Access Compliance Report Public Rights-of-Way (Curb Ramps)

Main Street: ANTONIO_PKWY Cross Street: N/A Location: SW

ADA ID: RPRK211202125650 Ramp Type: Type 1 - Perpendicular Diagonal Initial Pass/Fail: Fail Overall Compliance: No Severity Score: 2

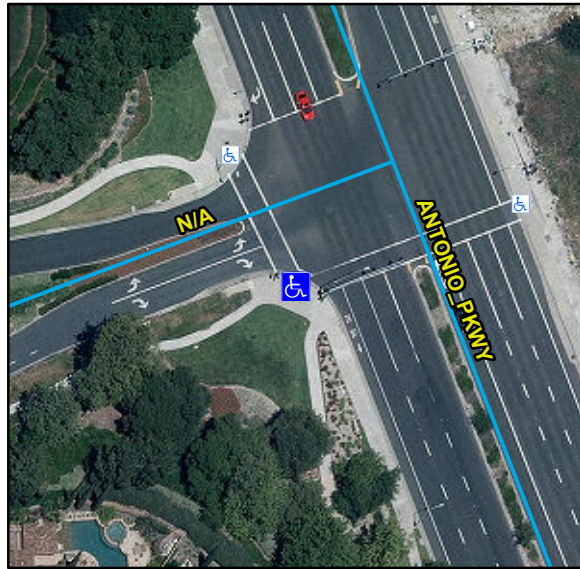
Compliance	Description	Data	Compliance	Description	Data
N/A	Ramp Length (in)	124	N/A	Flare Type LT	
Yes	Ramp Width (in)	48			N/A
Yes	Ramp Run Slope (%)	4.4	N/A	Flare Slope LT (%)	N/A
No	Ramp Cross Slope (%)	3.1	N/A	Flare Traversable LT	N/A
N/A	Landing Present	N/A	N/A	Flare Type RT	
N/A	Landing Length (in)	N/A			N/A
N/A	Landing Width (in)	N/A	N/A	Flare Slope RT (%)	N/A
N/A	Landing Run Slope (%)	N/A	N/A	Flare Traversable RT	N/A
N/A	Landing Cross Slope (%)	N/A	N/A	DWS Provided	N/A
N/A	Landing Movement Obstructed?	N/A	N/A	DWS Contrast	N/A
	Landing Movement Type	N/A	N/A	DWS Length (in)	N/A
N/A	Landing Shared	N/A	N/A	DWS Full Width	N/A
N/A	Clear Space	Yes	N/A	DWS Offset Left (in)	N/A
N/A	Clear Space To Crosswalk (in)	48	N/A	DWS Offset Right (in)	N/A
N/A	Marked Crosswalk 1	Yes	N/A	Marked Crosswalk 2	Yes
	Crossing 1 Direction	E		Crossing 2 Direction	N
	Marked Crosswalk 1 Width (in)	144		Marked Crosswalk 2 Width (in)	144

N/A	Ramp Inside Crosswalk 1	Yes	Yes	Ramp Inside Crosswalk 2	Yes
	Crossing 1 Slope (%)	2.7		Crossing 2 Slope (%)	4.1
	Crossing 1 Cross Slope (%)	2.2		Crossing 2 Cross Slope (%)	0.6
N/A	Gutter Ponding	N/A	No	Curb Slope	6.8
Yes	Gutter Lip Height (in)	0		Road Run Slope (%)	1
N/A	Gutter Run Slope (%)	N/A		Road Cross Slope (%)	3.3
N/A	Gutter Cross Slope (%)	N/A			
Yes	Overall Surface Condition: Acceptable		No	Perp Joint Present	No
	Cross Gutter Present?	No		Spandrel Present?	No
	Replace Cross Gutter?	N/A		Replace Spandrel?	N/A

Remove & Replace Curb Ramp With Two New Directional Ramps or Equivalent.

R304.2.2, R204.3, R304.5.3, STD 1115
